SUPPLEMENT TO PARTS CATALOGUE/TECHNICAL GUIDE Cal. 3M22A

CHANGE OF POWER RESOURCE AND PARTS INFORMATION FOR Cal. 3M21A, 3M22A

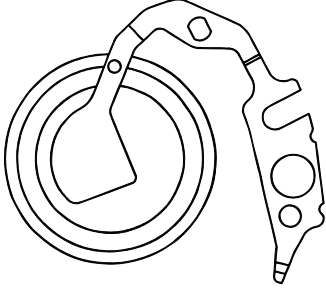
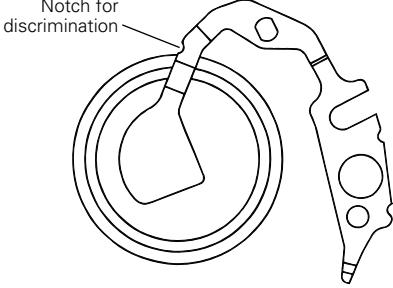
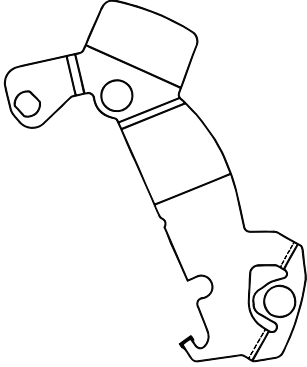
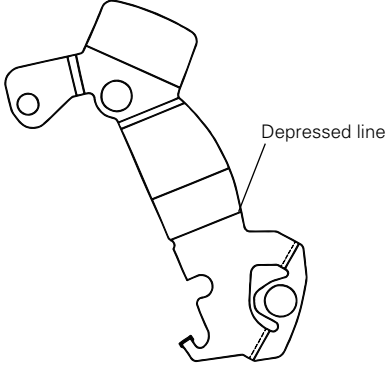
We would like to announce that the power resource and other parts for Cal. 3M21A/3M22A are changed to new ones which lead to enhanced performance and longer duration.

- When the new rechargeable battery unit is installed into the movement, please note that the original capacitor clamp should not be used. If the original clamp is used with new rechargeable battery unit, it could lead to short circuit or damage the movement. To avoid disorder, please order rechargeable battery unit and rechargeable battery clamp in a set by parts code "3027 3MZ" (3027 3MZ contains rechargeable battery unit and rechargeable battery clamp.)

- After the new rechargeable battery unit is installed, the indicator display for duration of charge will change. Please see below chart of "Comparative matrix between original and new power resource".

* When you change the original capacitor to new rechargeable battery unit, the clamp is also required to be changed. Please order them as a set by parts code 3027 3MZ to avoid confusion. (3027 3MZ contains rechargeable battery unit and rechargeable battery clamp.)
